**KNOXVILLE HISTORIC ZONING COMMISSION  
STAFF REPORT - CERTIFICATE OF APPROPRIATENESS APPLICATION**

**PROPERTY ADDRESS:** 609 Caswell St 37917

**FILE NO.:** 6-C-14-HZ

**DISTRICT:** Fourth and Gill H-1

1 FRONT ELEVATION CONCEPT 1  
SD1.1 1/4" = 1'-0"

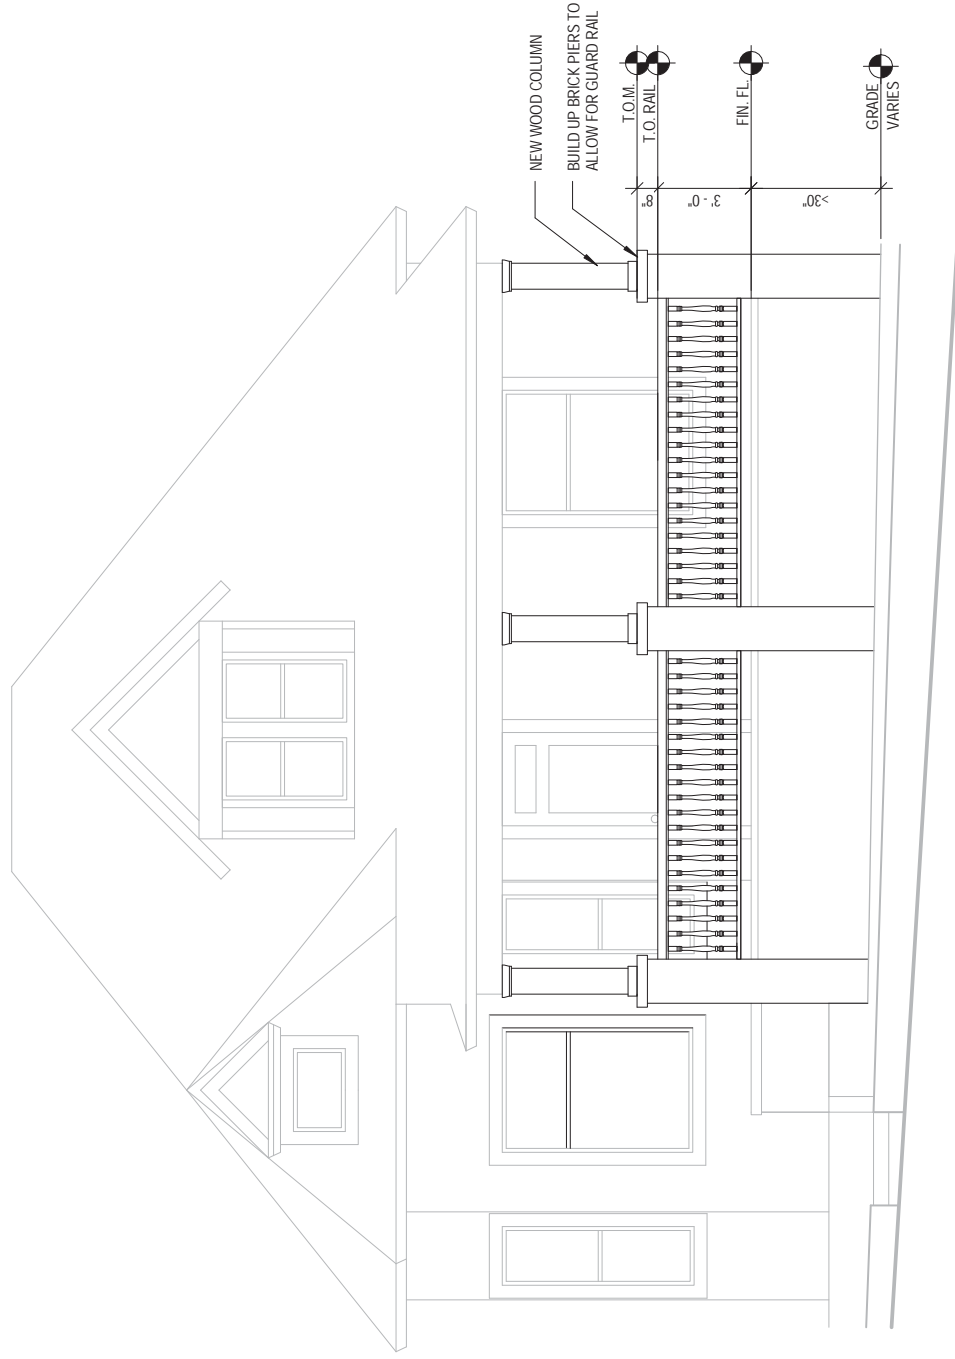
- 1) The Queen Anne cottage was built in approximately 1895 and the existing porch was added c. 1920.
- 2) Although the existing Craftsman battered porch columns and masonry balustrade cannot be dated precisely, the materials and design indicate that they date to the 1920s, in which case they are early enough to have acquired some degree of historic significance in their own right. However, the tall, solid brick wall supporting the porch is an ill-conceived design.

*Proposed Alterations to Porch.* We are submitting 2 options- one with a full wood porch column and one with a partial brick column. We believe the full-wood column is more representative of the original house, as seen in the photograph, but either would be great if the Commission thinks one or the other is more appropriate in context. See attached PDF for option 2.

1 FRONT ELEVATION CONCEPT 2  
SD1.2 1/4" = 1'-0"

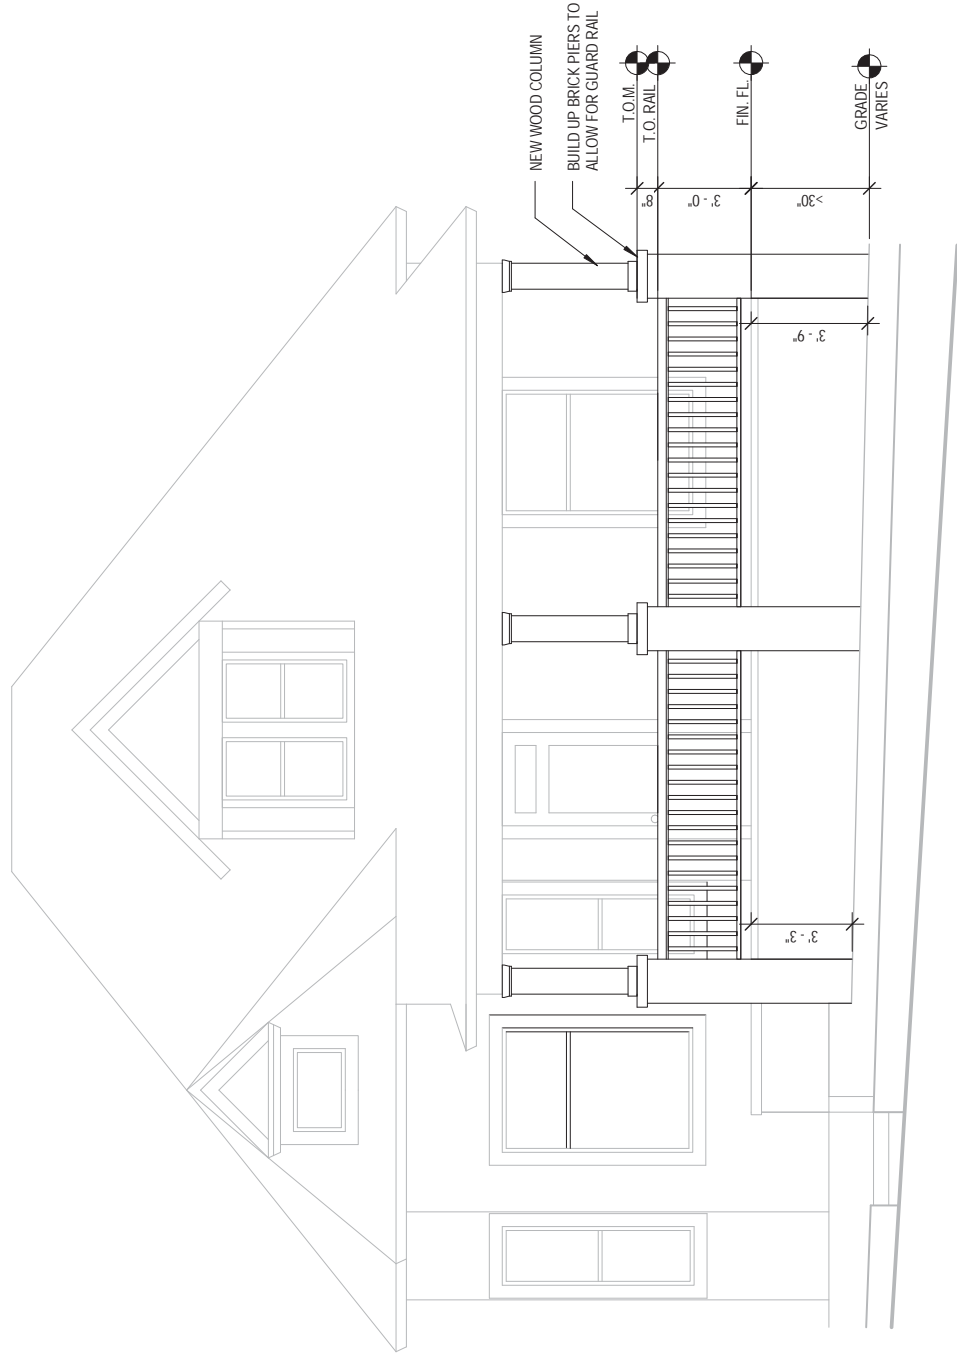
- 4) Some photo-documentation exists to indicate that the stairs leading up to the original porch, had a turned or square-picket balustrade.
- 5) The brick pier porch column supports shown in Option 2 would continue to convey the stylistic evolution of the porch from the Victorian to the Craftsman style. Simple square 2x2 balusters would be less conjectural than the turned balusters shown on the submitted drawings and would be compatible with the Craftsman-style square brick piers.

- 6) The proposed removal of the solid masonry balustrade will break up a tall expanse of stucco foundation, which currently causes the house to stand out as an anomaly among streetscapes where the porches are more at street-level and pedestrian-scaled.

Staff recommends approval of Option 2 with the condition of square 2x2 balusters based on the findings of fact and the design guidelines. The owner/applicant will be responsible for providing a property survey to Building Inspections to determine if any of the work is potentially within the City's right-of-way.
